**TO:** DEVELOPMENT REVIEW BOARD  
**FROM:** CURRENT PLANNING SERVICES  
**SUBJECT:** CASE 68-DR-2003  
**REQUEST:** Approve site plan & elevations for a restaurant to be located in an existing building  
**PROJECT NAME:** Loco Patron  
**LOCATION:** 4228 N Scottsdale Rd  
**DEVELOPER/OWNER:** Simonson Buildings Inc  
**ARCHITECT/DESIGNER:** Tebo LLC  
**APPLICANT/COORDINATOR:** Tebo LLC/Robert Briggs  
1330 W Culver St  
Phoenix, AZ 85007  
602-254-0151

**DATE:** December 4, 2003

**STAFF RECOMMENDATION:** APPROVE subject to the attached stipulations.

JOB NUMBER 0315  
DATE 10-28-05  
CONTENTS  
SITE PLAN

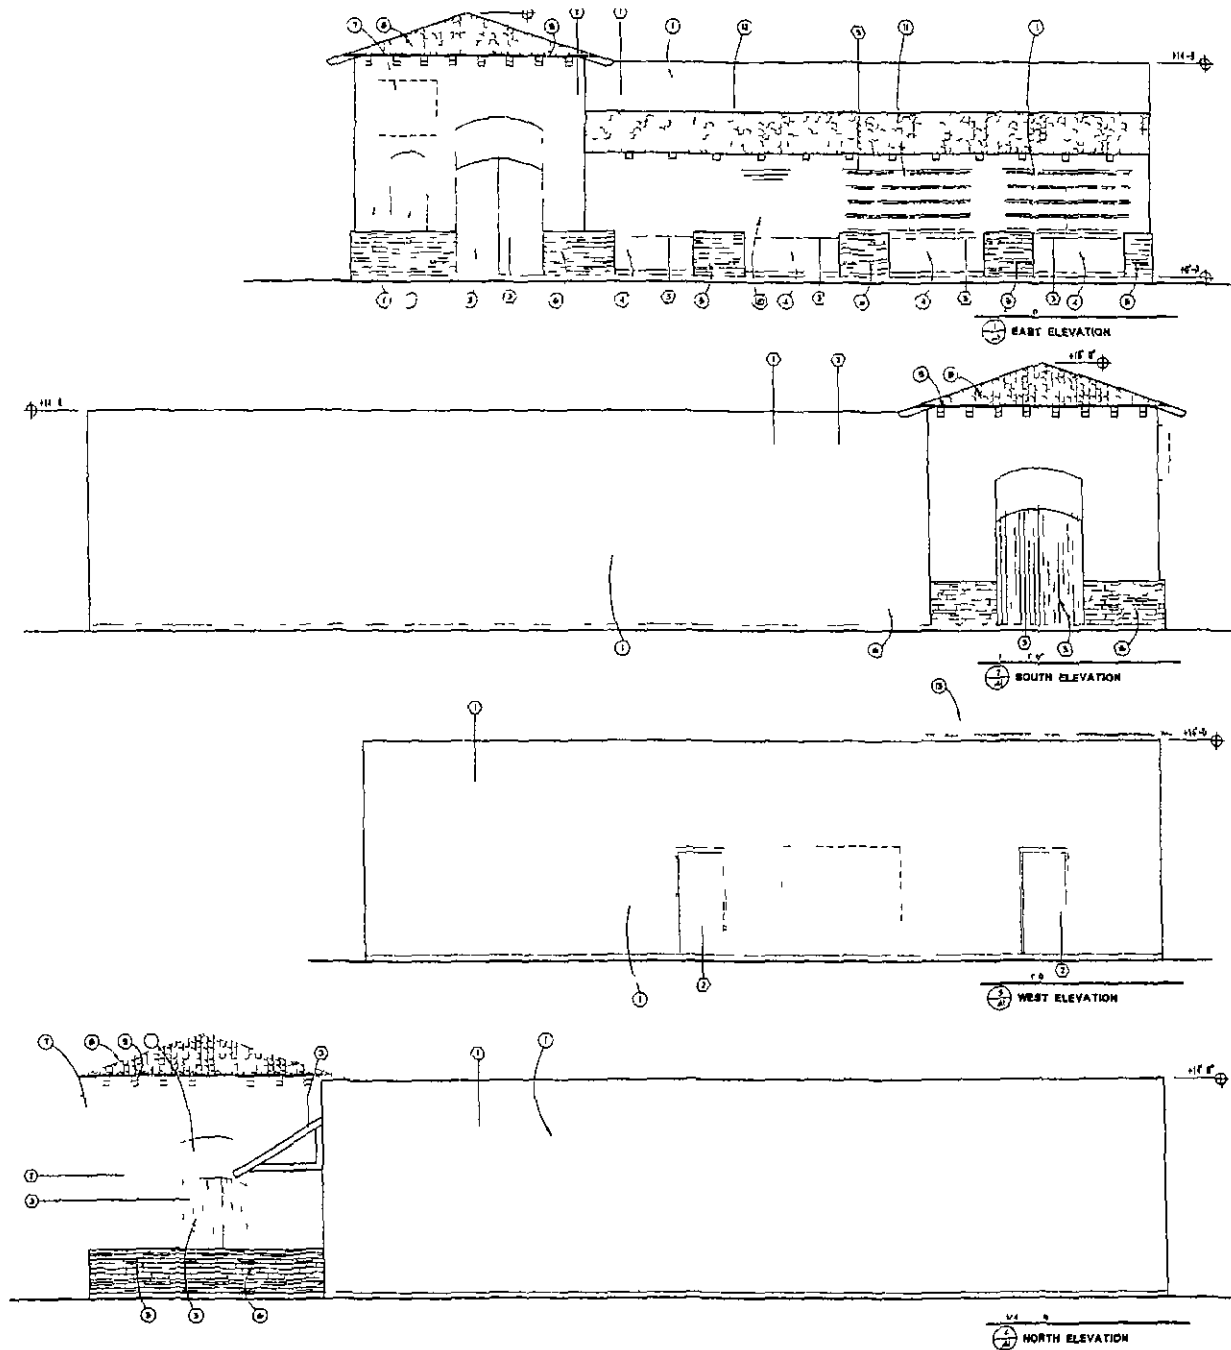
- a) The above agreement outlined above, must be obtained prior to final plans submittal and must be made a part of the final plans submittal package to the City of Scottsdale
- b) The developer shall not be allowed to place the restaurant's refuse enclosure at the proposed on-site location, as shown on the preliminary site plan, as there is not sufficient turning area for the refuse truck
